MAGNA ✓ CHEK ^M

SUBJECT: Control Number 77973 - Additional information to Amendment to License Number 21-19111-02 per telephone request by John Madera, USNRC, on April 25, 1985.

FIGURE 1
EXPOSURE CELL

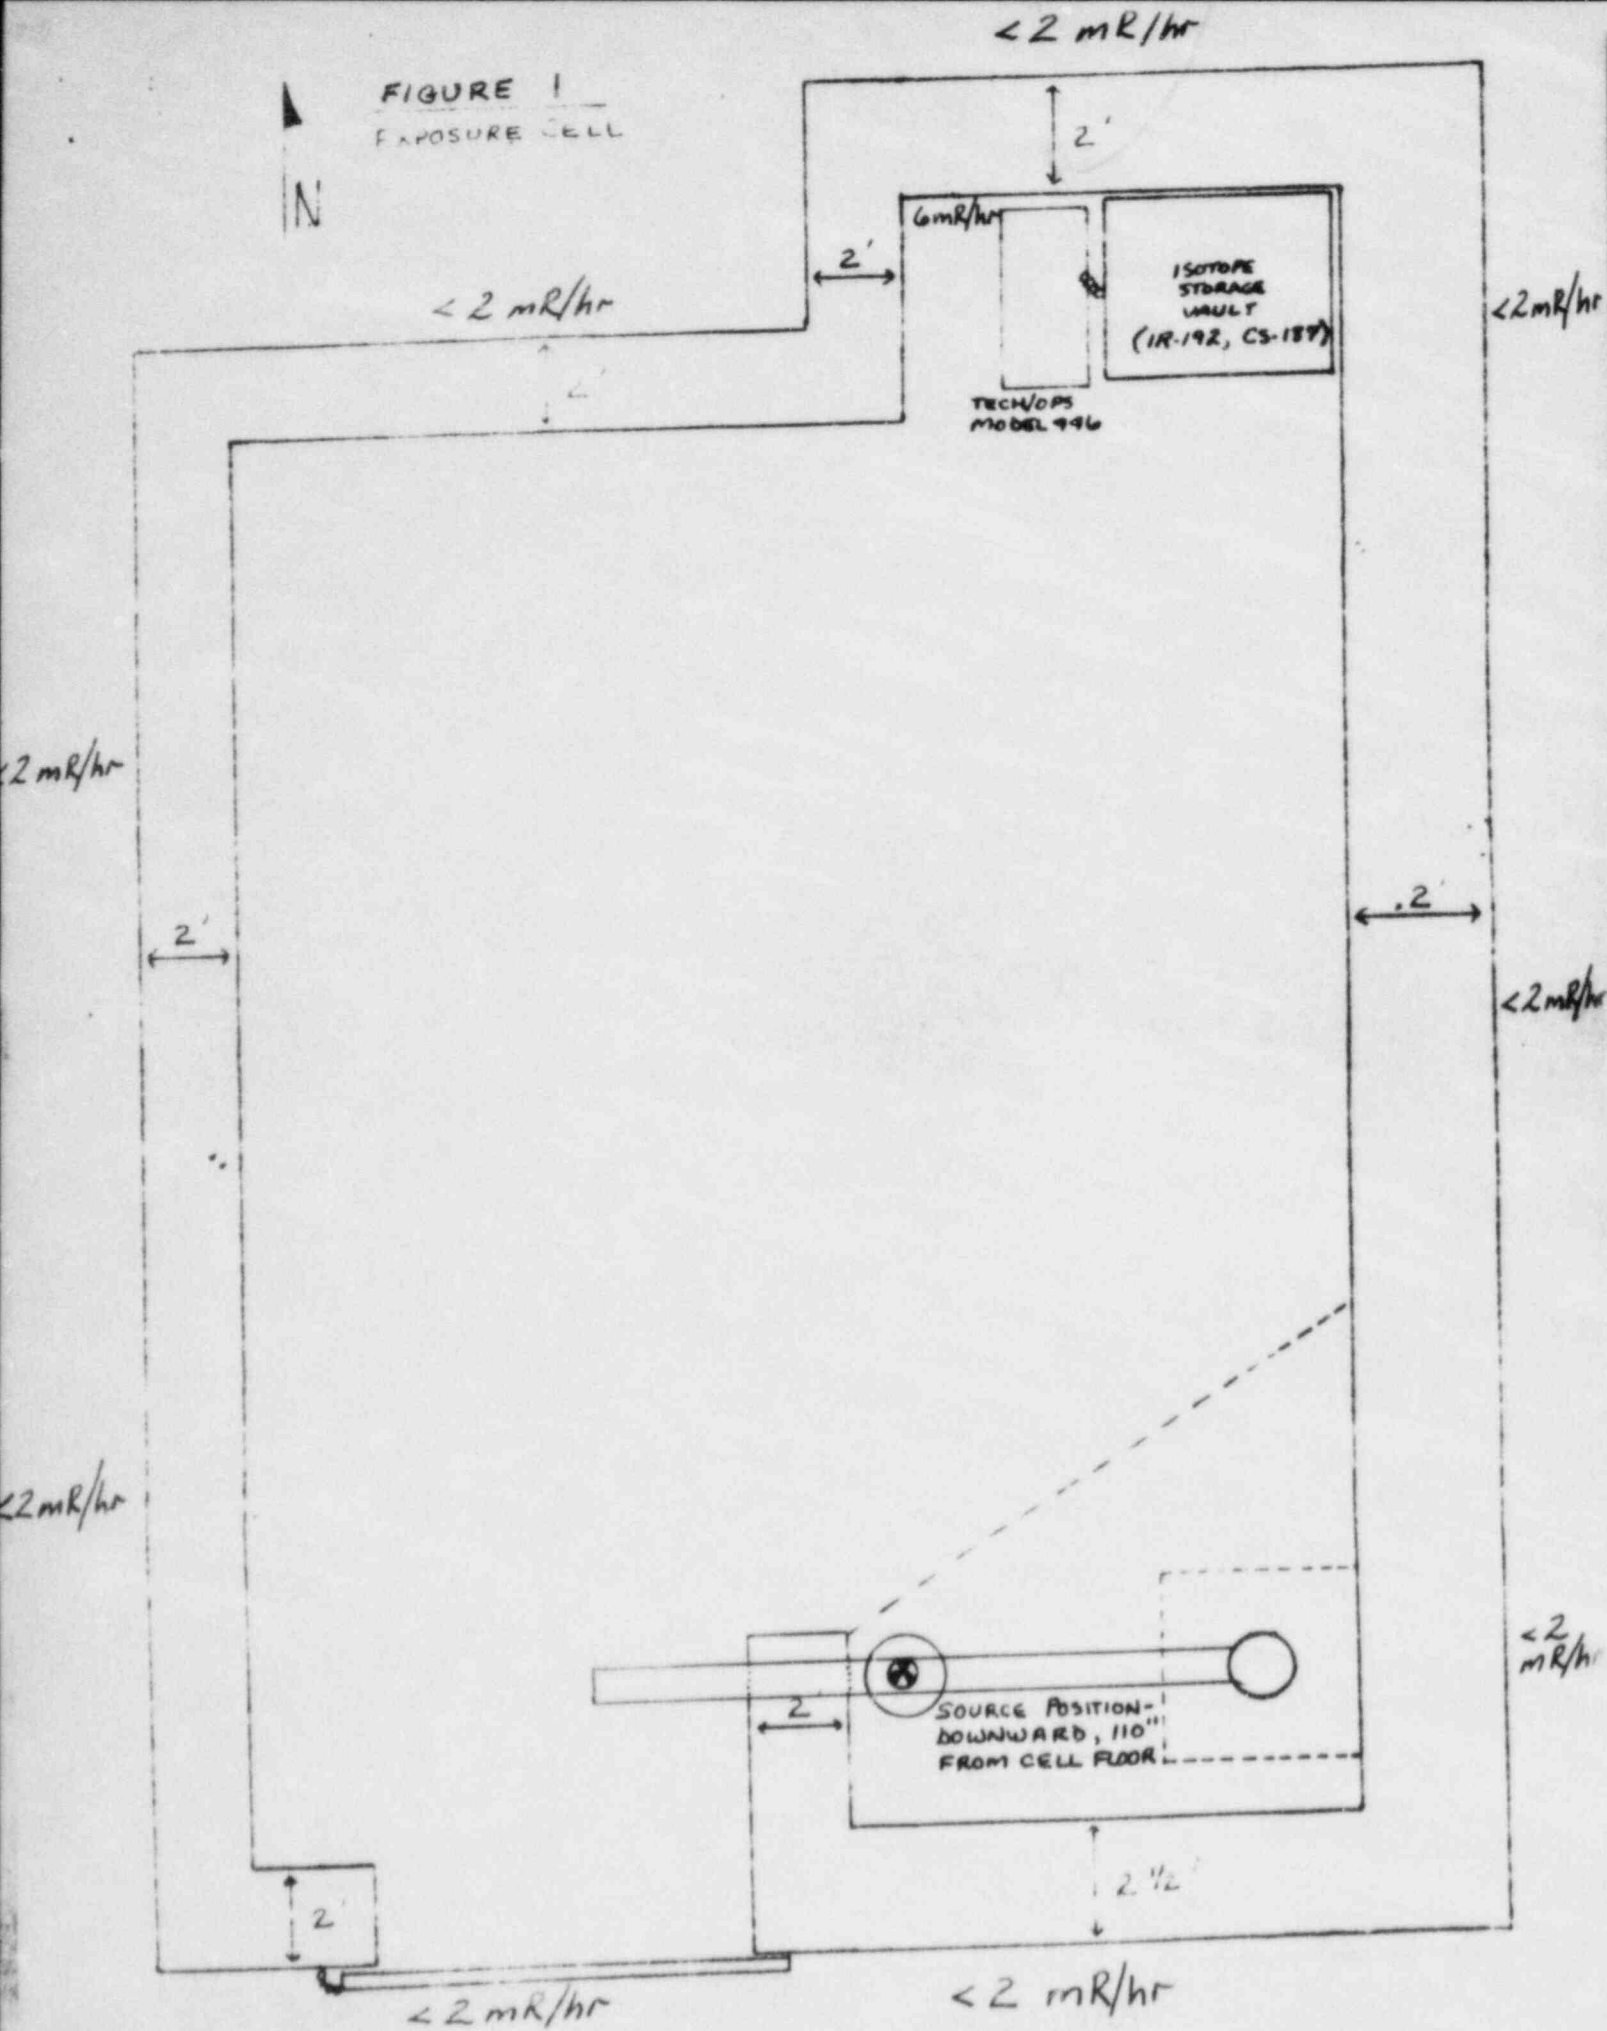
- Figure 1 - Surveys indicated that radiation levels at external surfaces of the exposure cell did not exceed 2 mR/hr.
- Figure 2 - Source positioned outside of the preferred exposure area. Surveys indicated that radiation levels at external surfaces of the exposure cell did not exceed 2 mR/hr, except at the surface of the exposure cell door where radiation levels were 20 mR/hr maximum. When levels of this intensity are present, the restricted area boundary is adjusted to reflect a 2 mR/hr intensity as shown in Figure 14.

FIGURE 3
EXPOSURE CELL

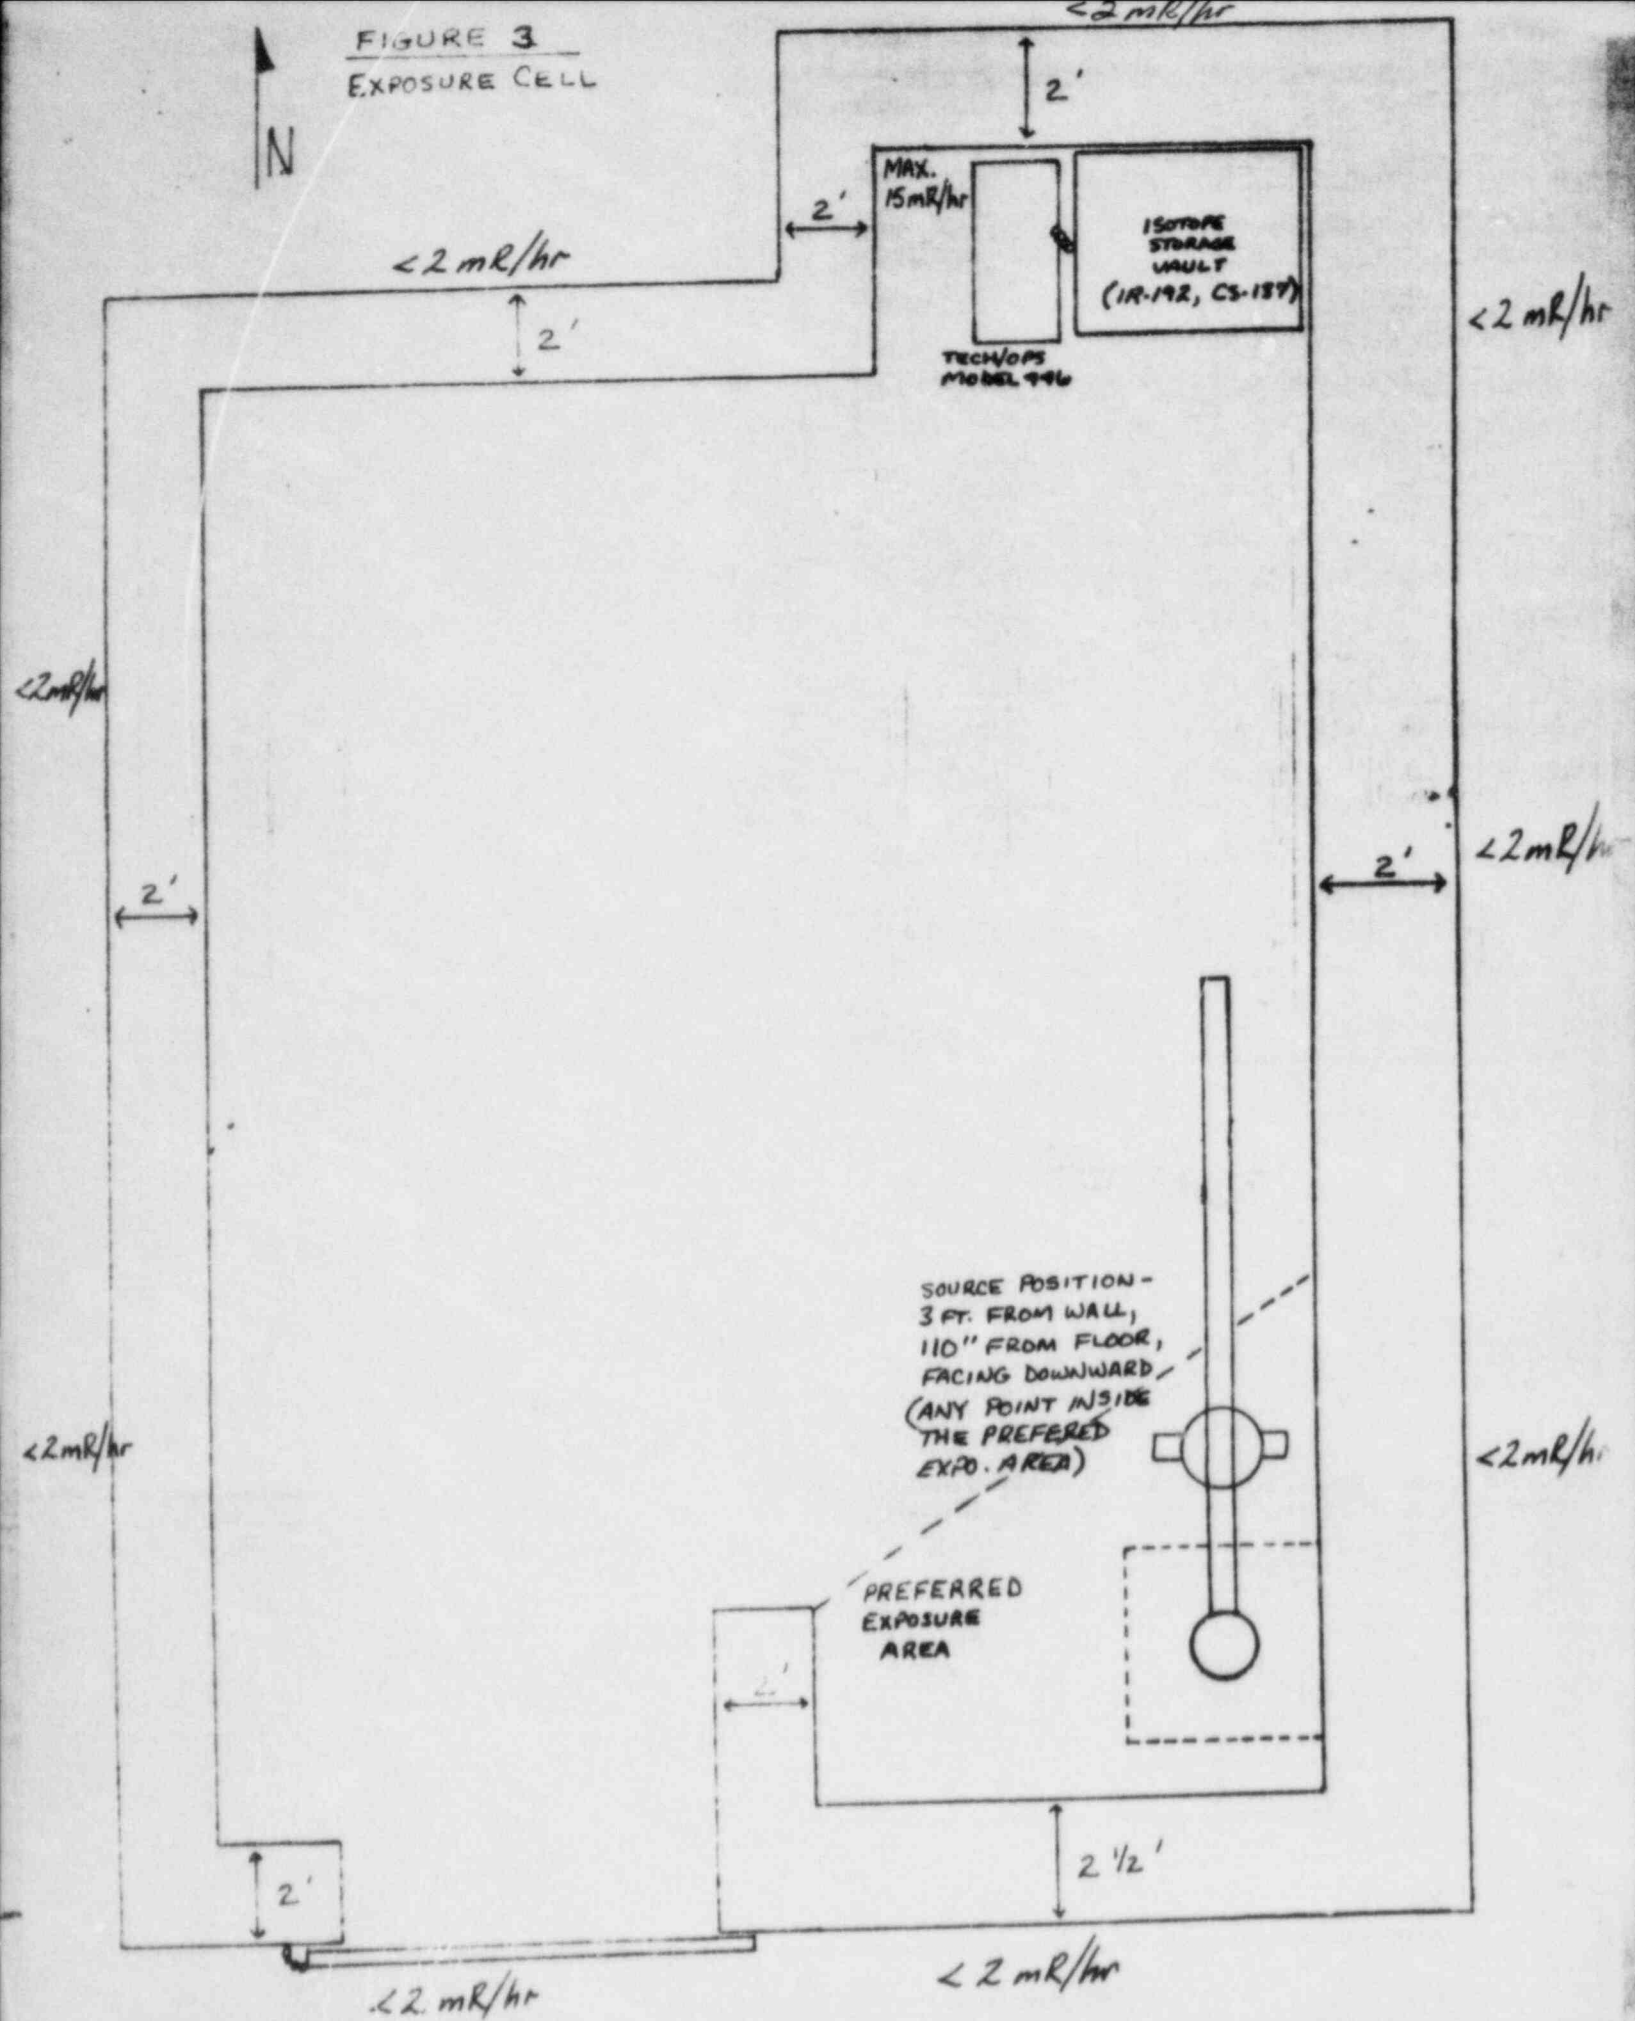
- Figure 3 - Surveys indicated that radiation levels at external surfaces of the exposure cell did not exceed 2 mR/hr when the source was in this position.

FIGURE 4
EXPOSURE CELL

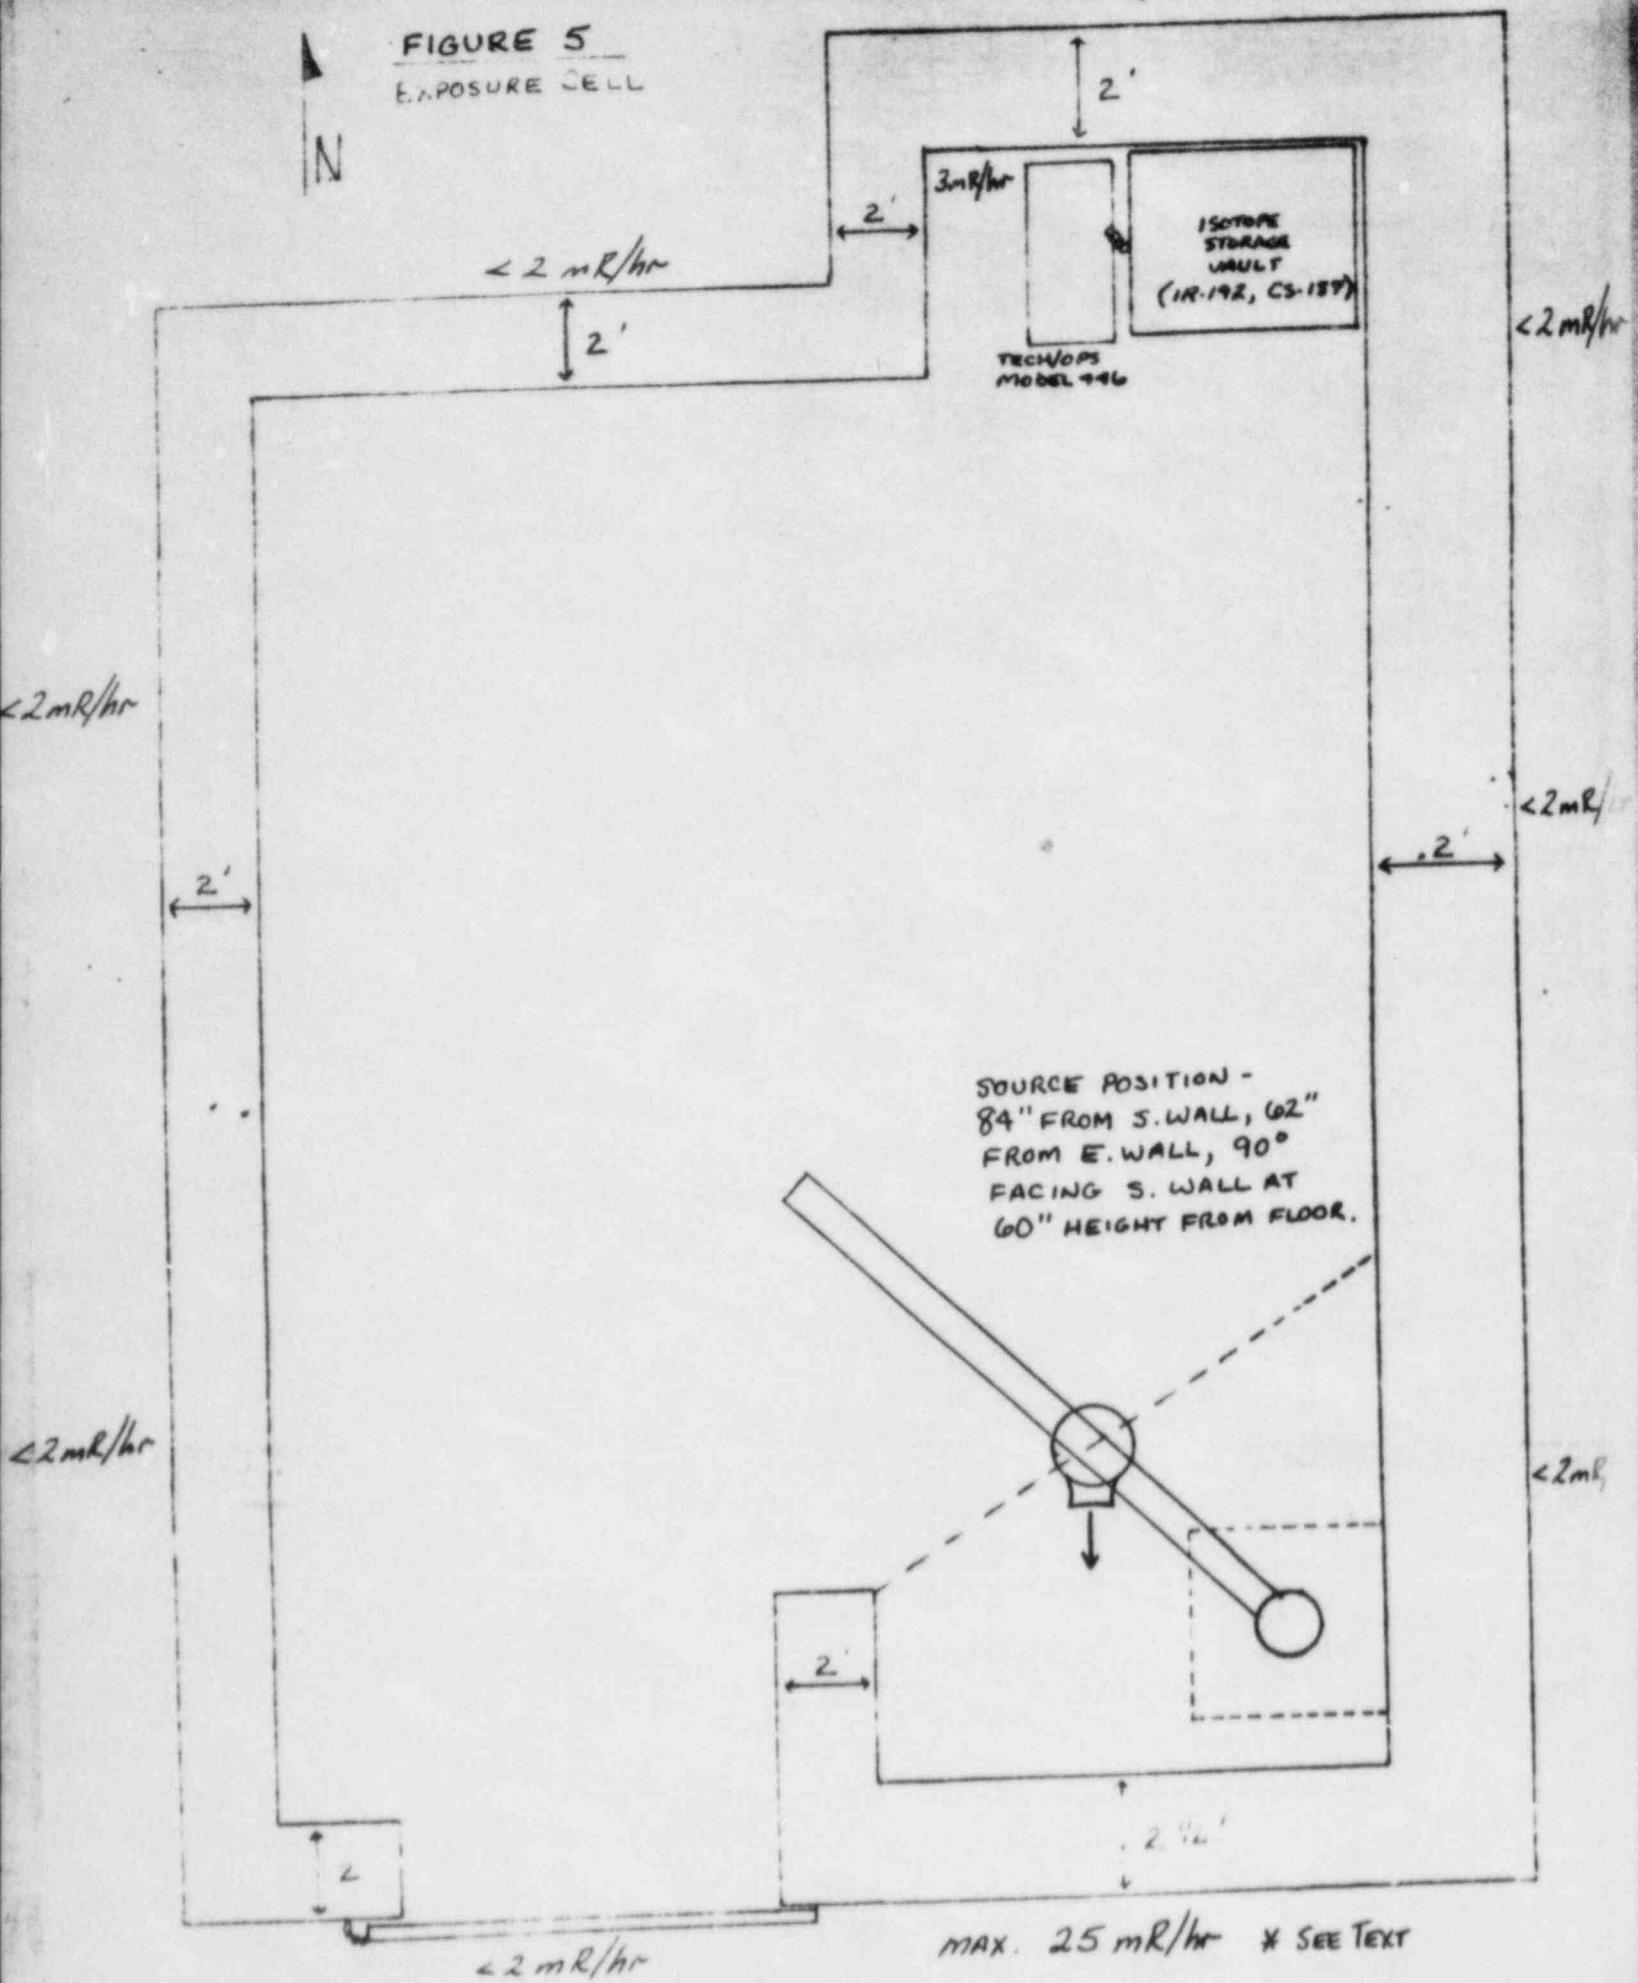
- Figure 4 - Surveys indicated that radiation levels at external surfaces of the exposure cell did not exceed 2 mR/hr with the exception of the cell door and portions of the west wall which were 4 mR/hr and 3 mR/hr respectively.
